## NON-COMPLIANCE REPORT # 32970-2

PART NAME: 3S DRIFT PUMP CAN (TOP HALF ONLY)  
 PF/SA NO.: PF-444-412-23 R0  
 WORK ORDER NO.: 32970-2  
 VENDOR: MFD

DATE: 4/6/16  
 INSPECTOR: K. CABAN  
 ENGINEER: J. VARGAS EXT.:  
 PLANNER: BILL

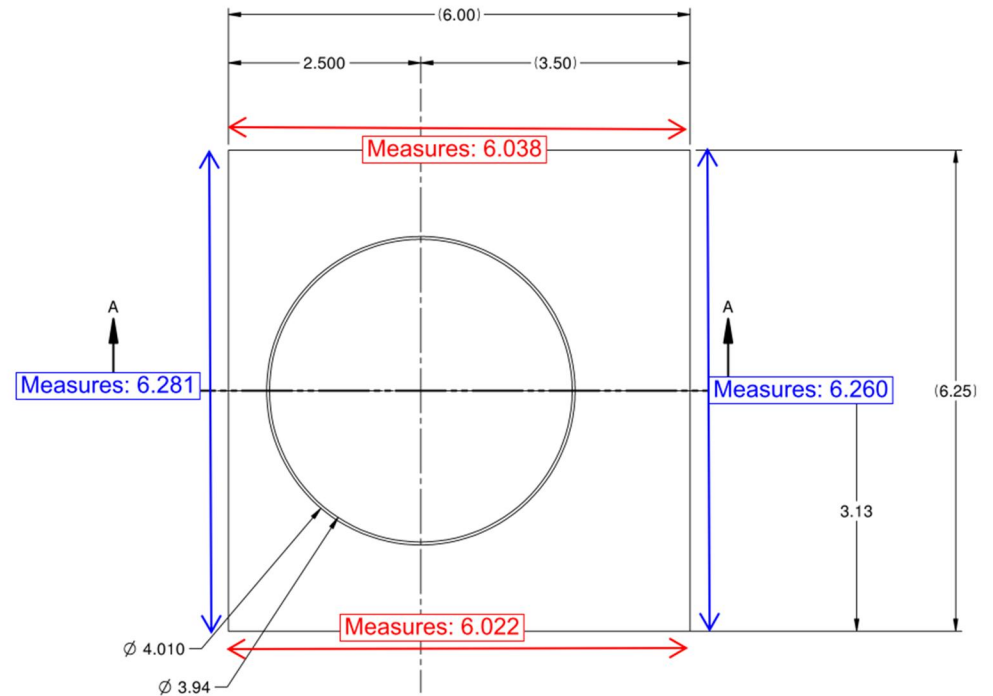
1. 6.00 ±0.01 tapers from 6.022 - 6.038 (+.012" to +.028" oversized)
2. 6.25 ±0.01 tapers from 6.260 - 6.281 (up to +.021" oversized)

*\*\*Inspection is for Top part only. Part is a remake (32811-2)-which was not QC'd by SLAC Metrology.*
